**Staff Report: Preliminary Plan No. 120090090: Montgomery Village Marketplace
 Site Plan No. 820090060: Montgomery Village Marketplace**

MCPB HEARING DATE: September 17, 2009

REPORT DATE: September 4, 2009

Figure 6: Proposed Improvements along Stedwick Road.

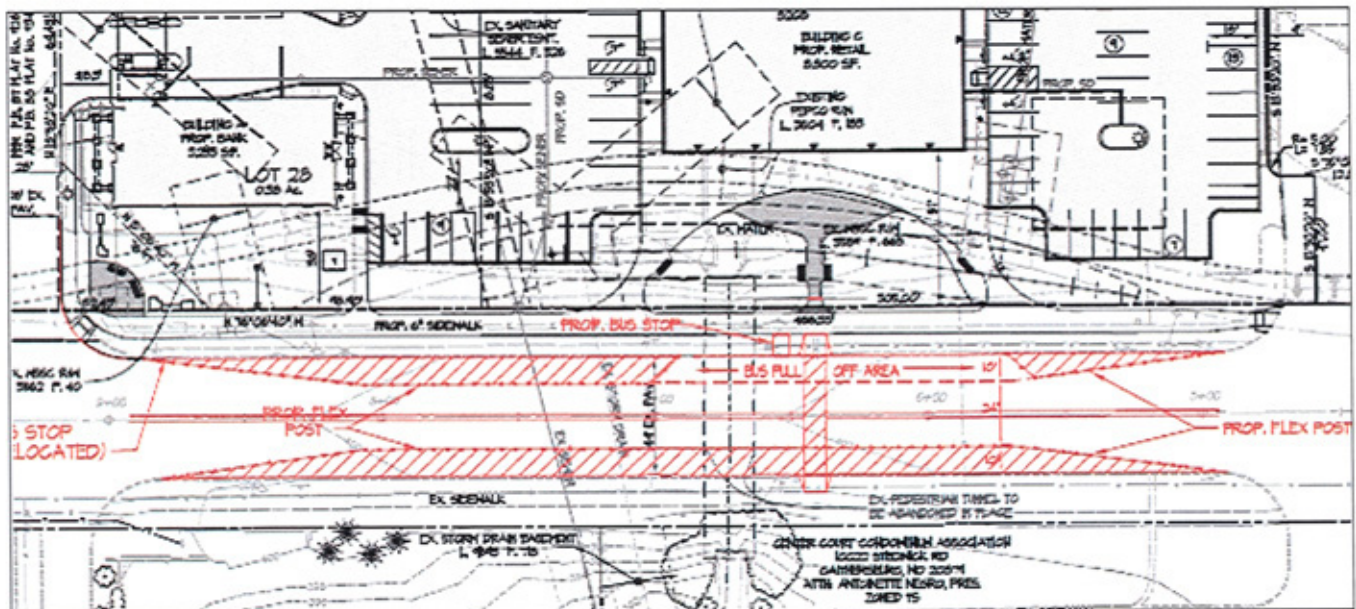
During the course of this review, several issues came up related to the closure of the pedestrian tunnel underneath Stedwick Road, the most recent being the plans from MCDOT – Division of Transit Services to construct a transit layover facility along the Stedwick Road frontage of the site [Appendix B].

As a result of the tunnel closure, the Applicant was required to provide an alternative at-grade mid-block crossing on Stedwick Road. The preferred layout by MNCPPC included a median on Stedwick Road, given that the original recommendation to have bump-outs and crosswalks at the intersections was not acceptable to DOT. The chosen layout, which evolved from the layout on the image below (Figure 6), includes chokers at the proposed mid-block crosswalk and restriping of Stedwick Road between Montgomery Village Avenue and the shopping center driveway (opposite Mills Choice Road) to narrow the travel lanes in each direction, but no median.

The mid-block crosswalk is aligned with the proposed plaza on the subject site. However, on the south side of Stedwick Road, there is a considerable grade change between Stedwick Road and the existing pedestrian system, which connected to the tunnel. Therefore, the Applicant was directed to provide stairs and an ADA path to connect the existing pedestrian system to the new mid-block crosswalk. The communities of Center Court and Heron's Cove are opposed to having stairs (and initially the ADA path) on their property because of liability and maintenance issues.

Figure 7: Preliminary Plan

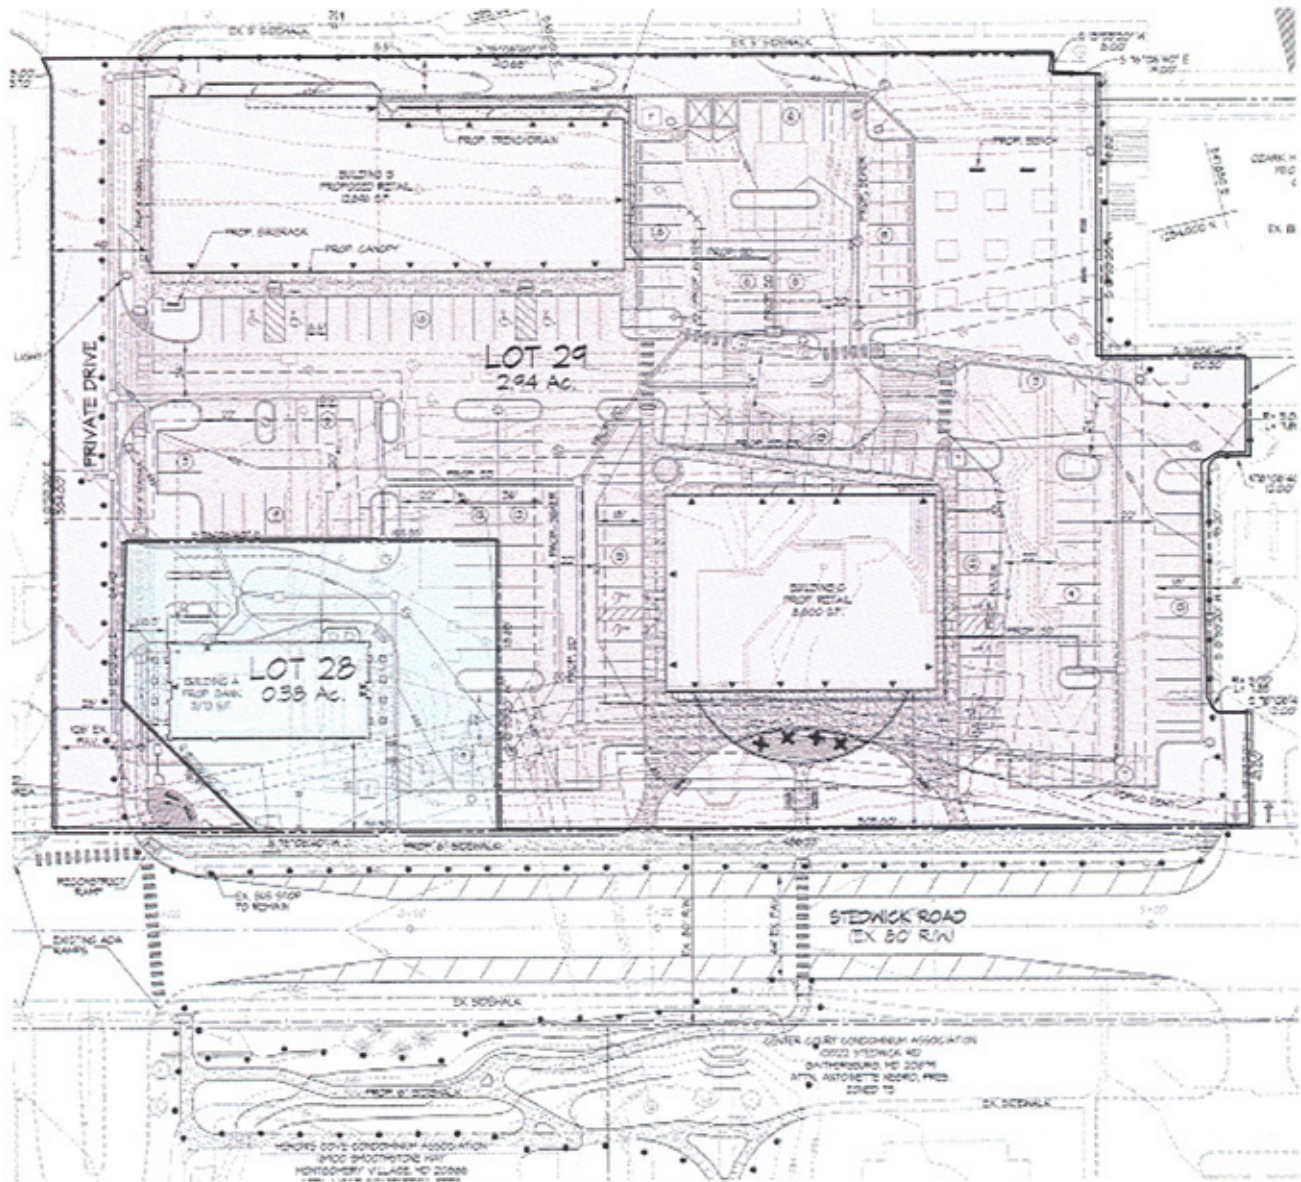
The importance of a pedestrian circulation system, throughout the Village and within individual sites, has been consistently emphasized as part of site plan review. The sidewalks along the property frontage are to be rebuilt and upgraded from 6 feet to 8 feet in width connecting to an 8 foot sidewalk along proposed Building C. A sidewalk along the private drive on the western portion of the site will provide access to the Subject Property and retail destinations to the north. A sidewalk along proposed Building B will connect to the sidewalk system within the property directly to the east of the site. An at-grade mid-block crossing will connect the project to confronting properties along Stedwick Road. Specialty pavers are used throughout the pedestrian areas to define spaces and unit pavers are utilized at various crossing locations to serve as a traffic calming measure.

Community Based Planning Staff in their memo dated September 2, 2009 [Appendix B] recommends strengthening the internal pedestrian connections to conform with the new external connections. For example, the north-south connection should be completed through the center of the site, where pedestrians are now being directed. In addition, Community Based Planning Staff recommends connecting the sidewalk on the east side of the bank building to Building B by adding sidewalks to the planting islands, with crosswalks in between as well as adding four-foot paths to the corner parking islands on the southeast and southwest corners of Building C so that pedestrians don't have to walk between cars to access Building C. While these recommendations will increase pedestrian connections, Site Plan Staff did not believe these additional measures are necessary because the proposed pedestrian system adequately accommodates pedestrians without compromising vehicular safety.
